Project: PRA-ROCR 10(5)
The purpose of this Amendment is to:

Amendment No. 0002
Project PRA-ROCR 10(5)
Rock Creek Park
Solicitation: DTFH71-16-R-00001

Project Name: Beach Drive from Rock Creek Parkway to Maryland State Line

AMENDMENT NO. 2 ◇1	PMIS NO.	NPS NO.	STATE	PROJECT	SHEET NO.
	044965	821 / 100425	DC	PRA-ROCR 10(5)	D57

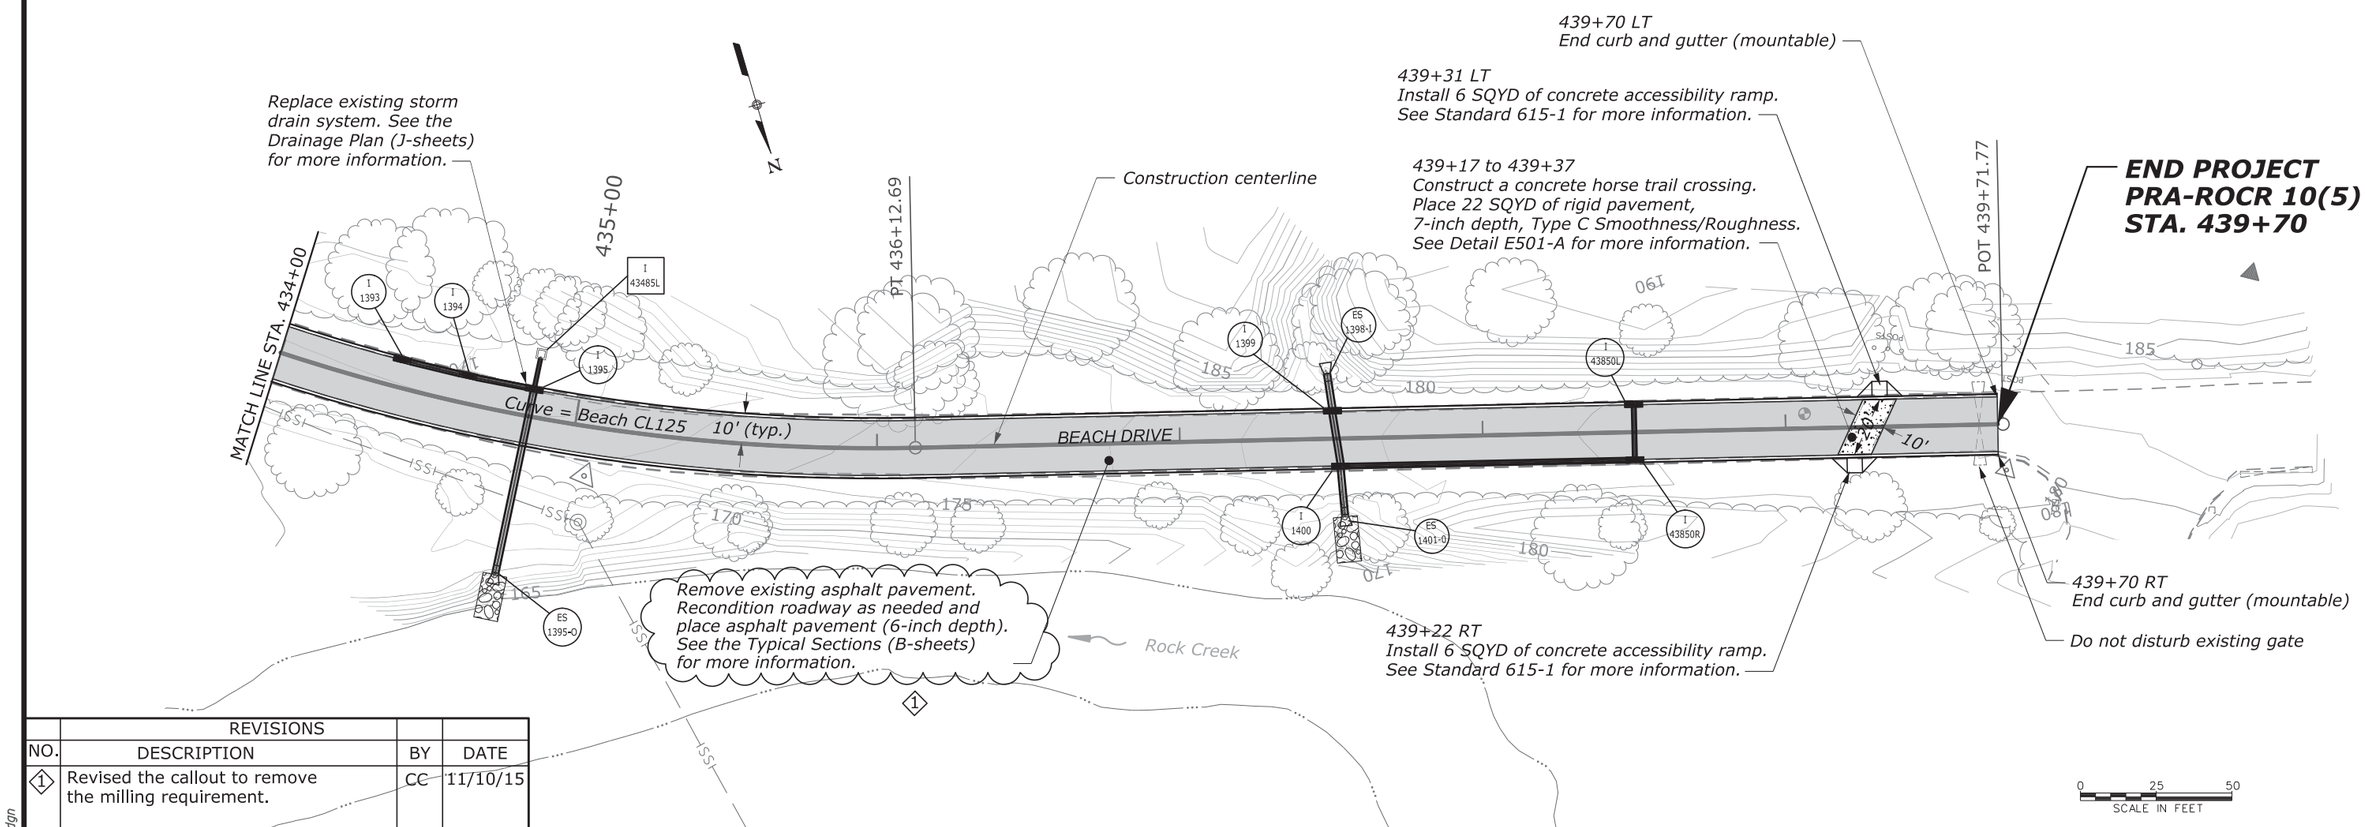
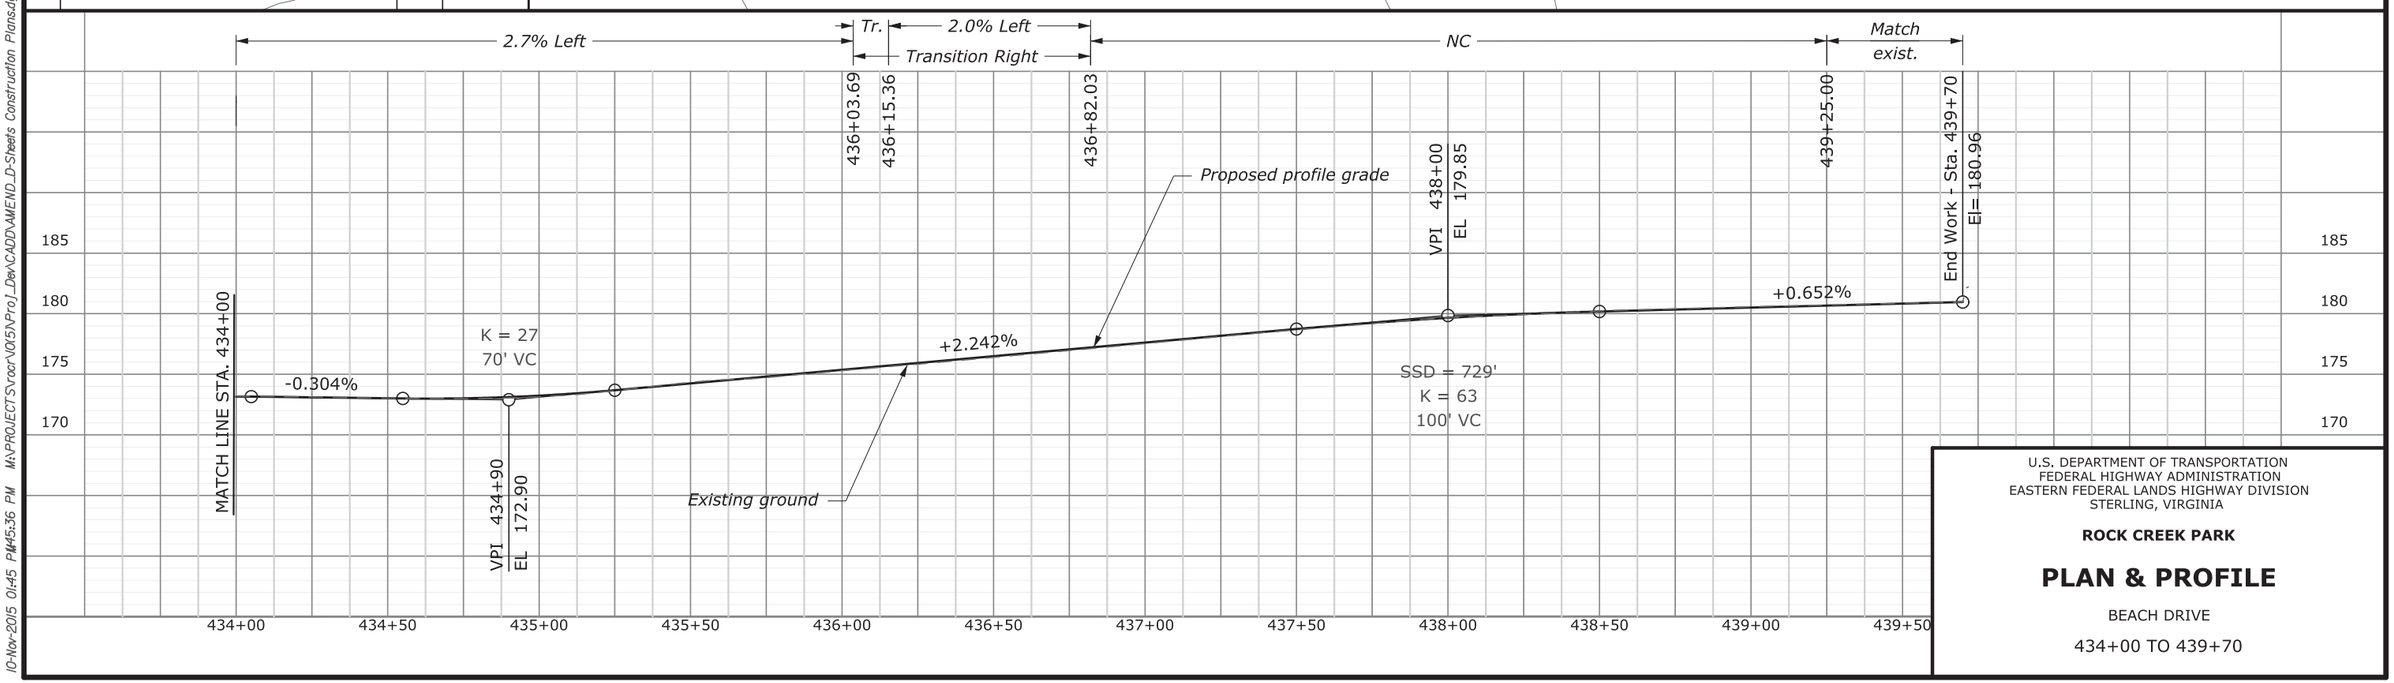
REVISIONS			
NO.	DESCRIPTION	BY	DATE
◇1	Revised the callout to remove the milling requirement.	CC	11/10/15

AMENDMENT NO. 1 ①	PMIS NO.	NPS NO.	STATE	PROJECT	SHEET NO.
AMENDMENT NO. 2 ②	044965	821 / 100425	DC	PRA-ROCR 10(5)	E15

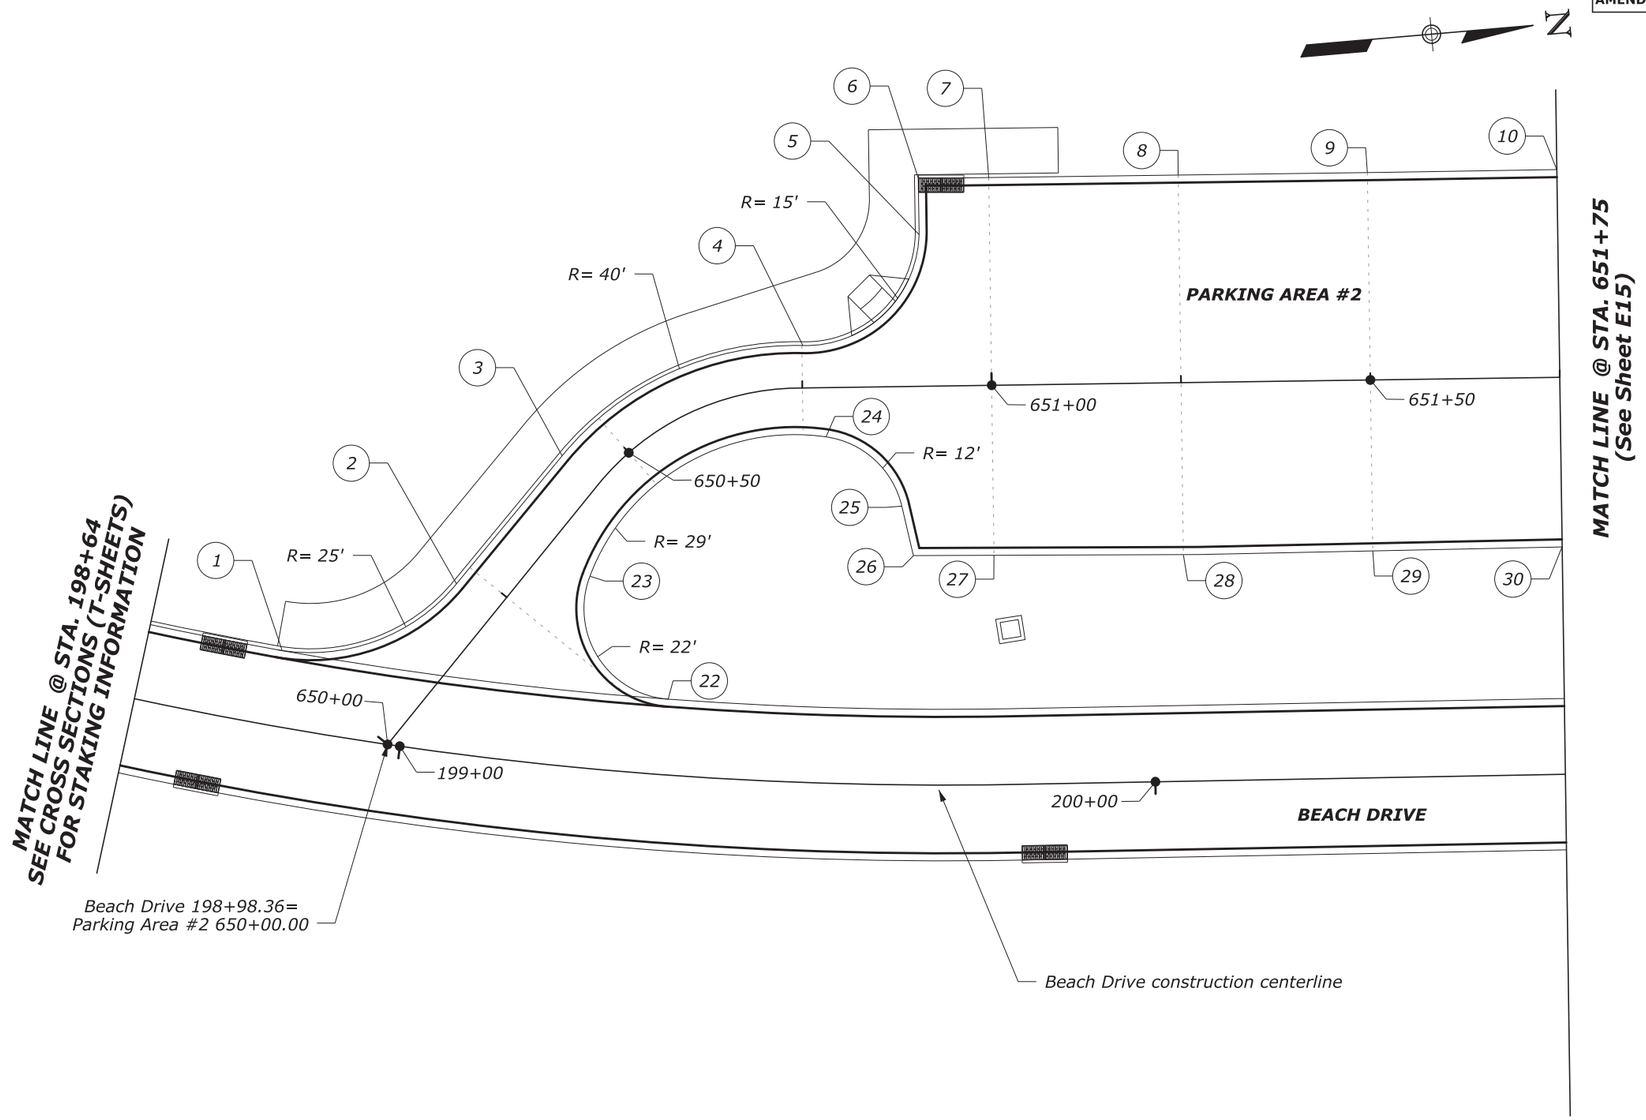
b) Sheets E15 and E16 updated to revise the Amendment 1 revision block description to show the correct plan sheet replacement.

REVISIONS			
NO.	DESCRIPTION	BY	DATE
①	Replaced sheet E15 with amendment sheet E15. One inlet was deleted and one inlet was added.	CC	10/22/15
②		CC	11/10/15

AMENDMENT NO. 1 ①	PMIS NO.	NPS NO.	STATE	PROJECT	SHEET NO.
AMENDMENT NO. 2 ②	044965	821 / 100425	DC	PRA-ROCR 10(5)	E16

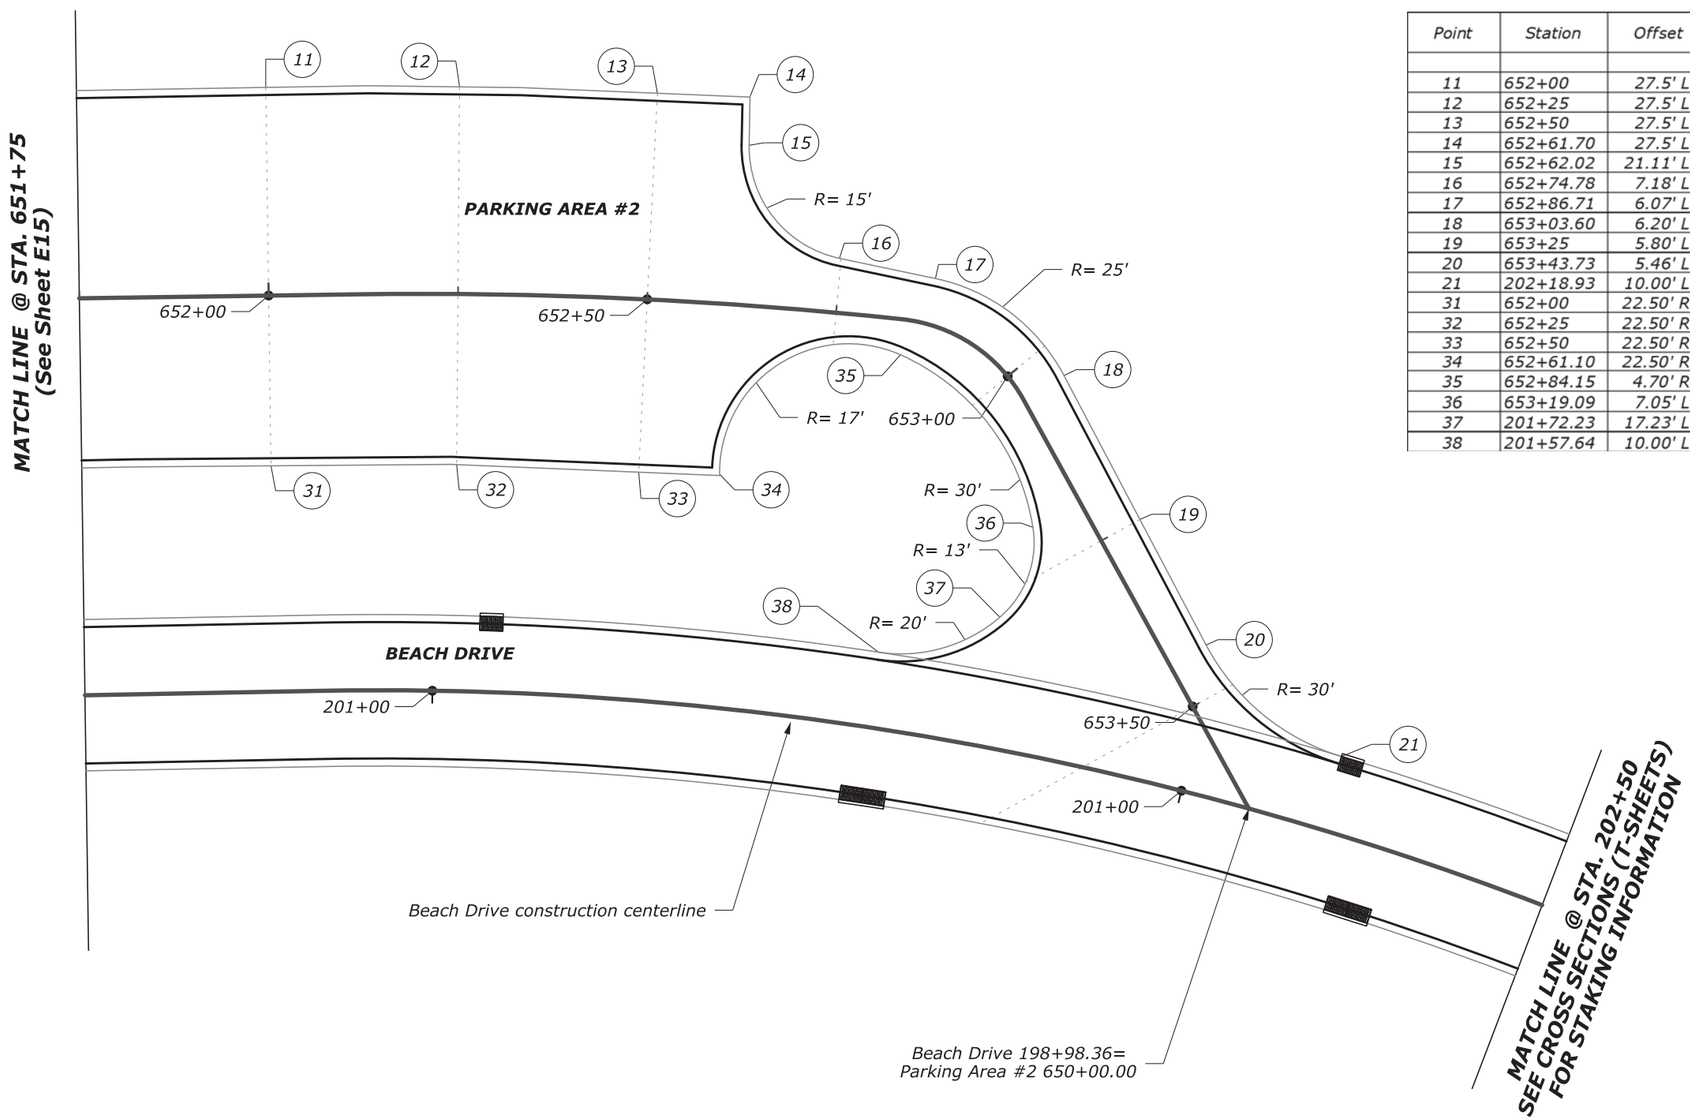
REVISIONS			
NO.	DESCRIPTION	BY	DATE
①	Replaced sheet E16 with amendment sheet E16. One inlet was deleted and two inlets was added.	CC	10/22/15
②		CC	11/10/15

AMENDMENT NO. 2 ①	PMIS NO.	NPS NO.	STATE	PROJECT	SHEET NO.
	044965	821 / 100425	DC	PRA-ROCR 10(5)	F06

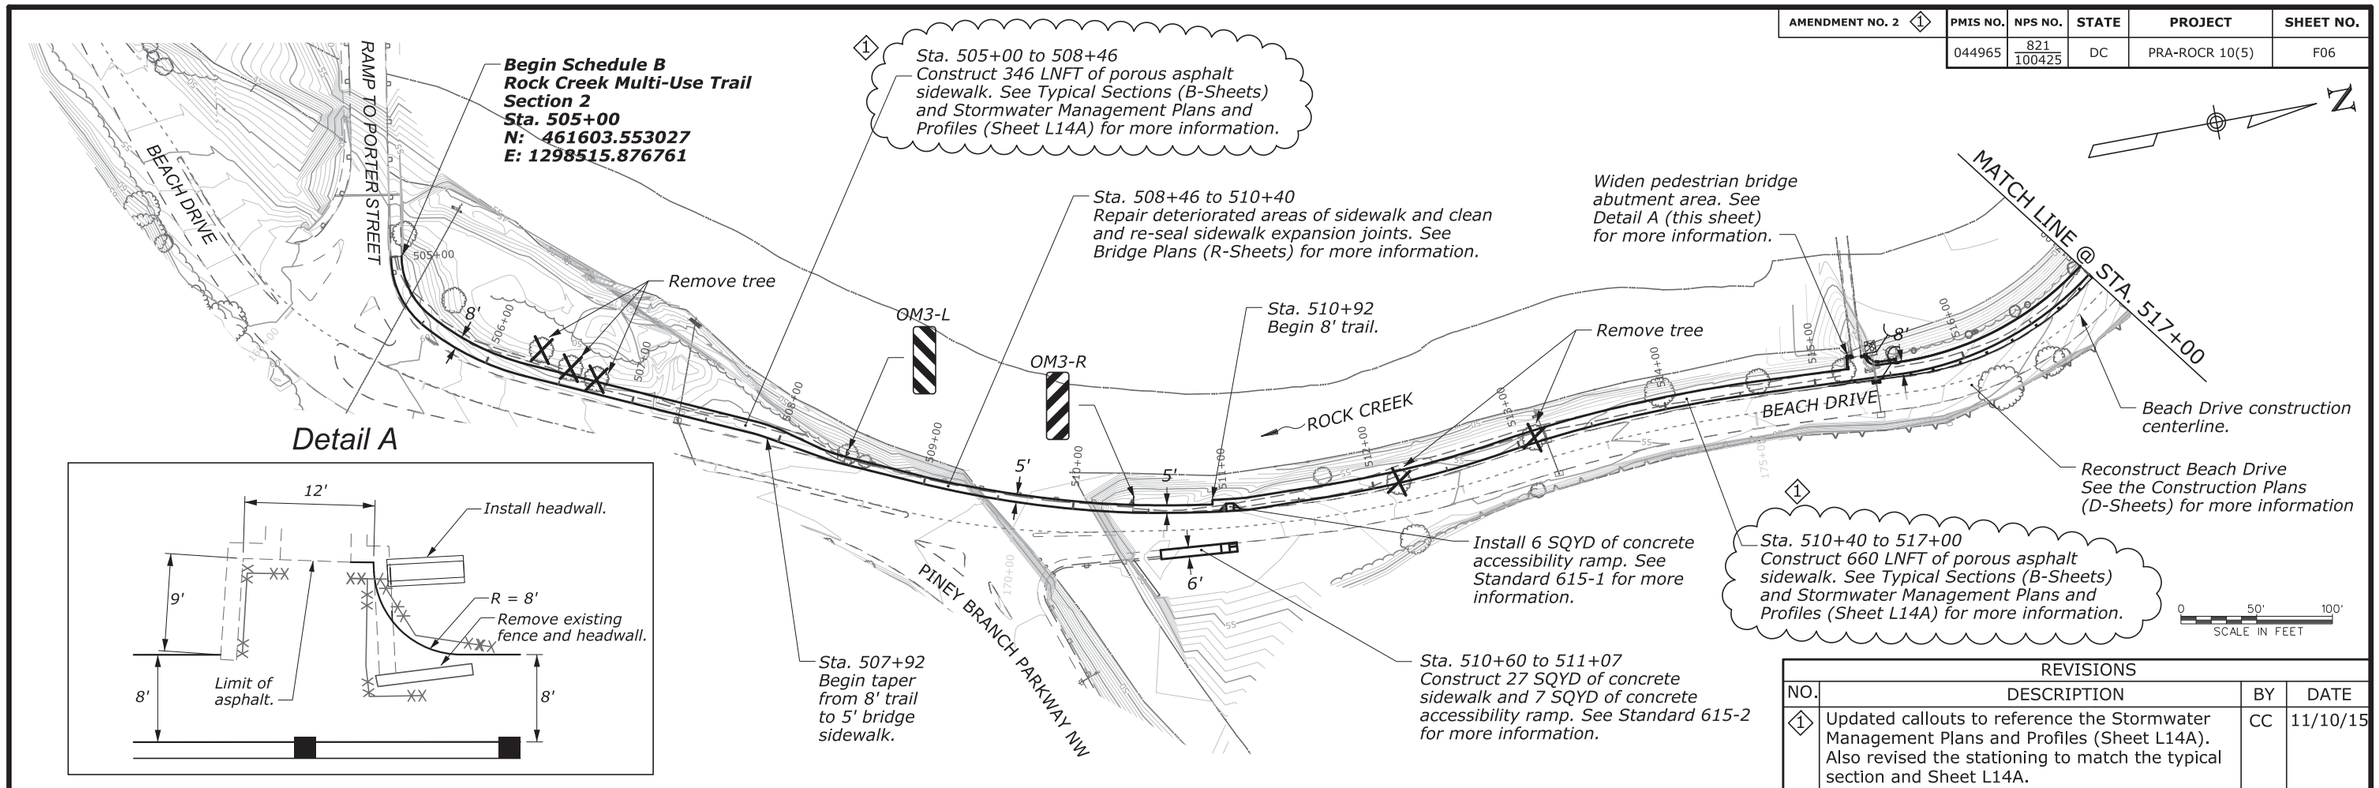
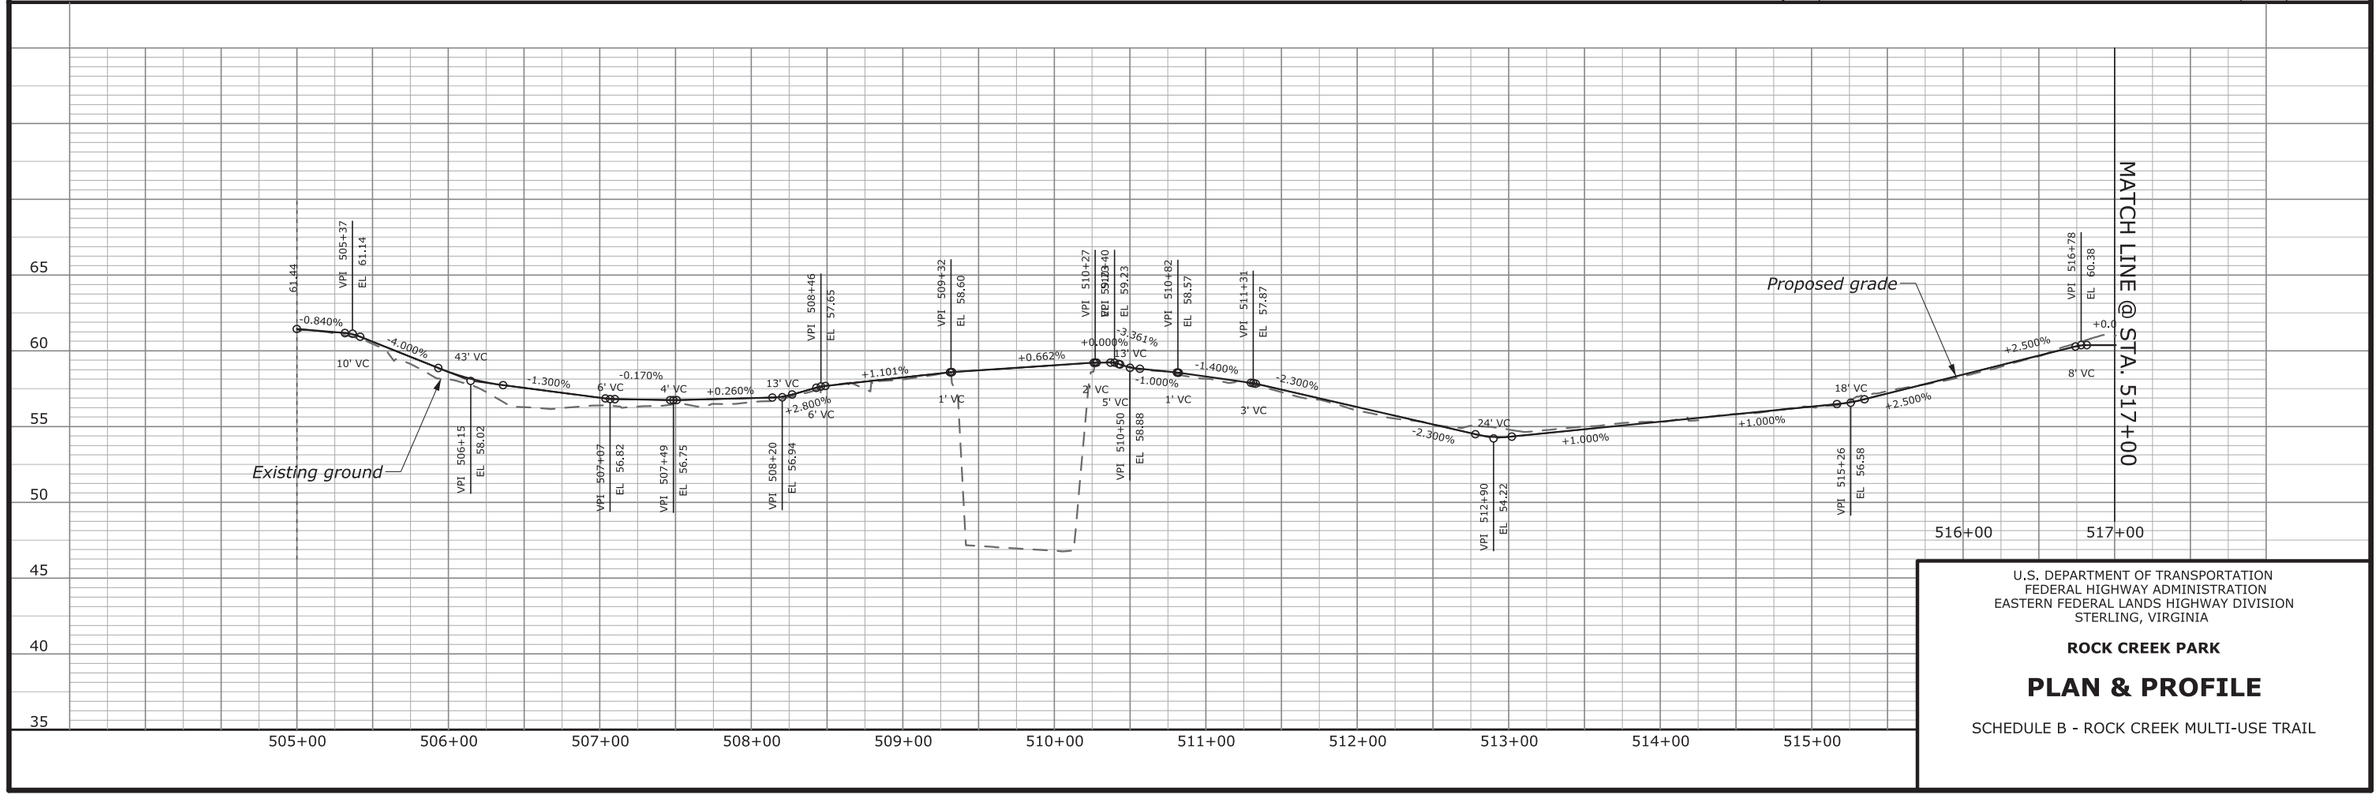
b) Sheet F06 updated to revise callouts for the porous asphalt sidewalk work in order to reference Plan Sheet L14A and revise the stationing to match the stationing in the typical section and Plan Sheet L14A.

REVISIONS			
NO.	DESCRIPTION	BY	DATE
①	Updated callouts to reference the Stormwater Management Plans and Profiles (Sheet L14A). Also revised the stationing to match the typical section and Sheet L14A.	CC	11/10/15
